December 11, 2014

Re: SR 99: Shaft Excavation Status Report & Action Items for Discussion
TBM Access Shaft, Seattle, WA

Figure 1: West Shaft Wall Design In-Fill Areas (Solid Gray Shaded Areas)

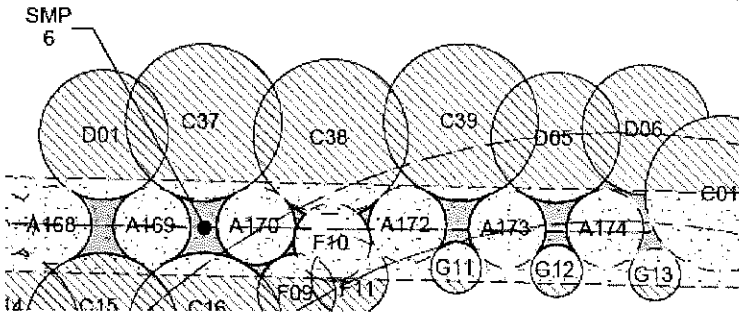
Reviewing the as-built locations of the shaft piles at regular vertical intervals, we are concerned that there is a potential for much larger untreated soil zones to exist than initially considered in the design, depending on the location of the SESMP piles. The design pile layouts shown in Figure 1 and Figure 2 indicate the originally expected in-fill or void areas in solid gray.

Figure 4: East Shaft Wall Pile As-built (Potential Void Areas Highlighted in Yellow or Hatched)

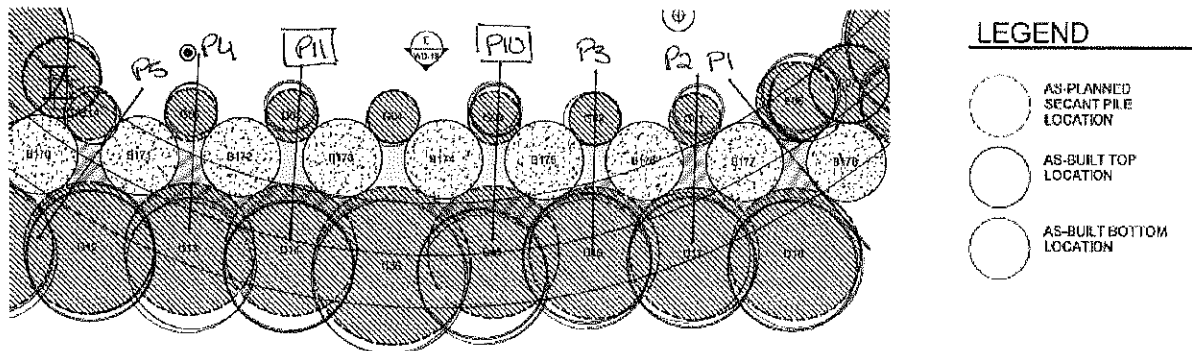
Upon review of the as-built secant pile locations with respect to the SESMP piles, there appears to be a potential for much larger in-fill areas than initially intended in the design. Given the observed untreated soil zones in the in-fill areas to date, the as-built pile layouts shown in Figure 3 and Figure 4 indicate the extent of potential untreated areas in yellow. Potentially untreated soil zones that fall within the theoretical design compression ring. A continuous compression ring of adequate thickness and strength is essential for the structural stability of the wall.

While it is likely the in-fill areas and associated untreated soil zones are larger than initially intended, we do not believe they are as extensive as shown in the as-built pile layouts of Figure 3 and Figure 4. For example, Figure 4 shows the potential for a nearly continuous void through the entire width of the shaft wall between piles B177/F06 and B178/D18. However, if this were the case, we believe that significant seepage and ground loss would have been observed during the course of excavation to date. Given the rate of seepage observed and the lack of ground loss outside the shaft, it is likely there is some continuous wall present between piles B177/F06 and B178/D18.

The source of the uncertainty for the as-built condition is the lack of as-built data for the SESMP piles. Once the as-built of the SESMP piles is incorporated into the existing overall shaft as-built, a more refined analysis of the ring-structure can be completed and critical in-fill repair locations identified.
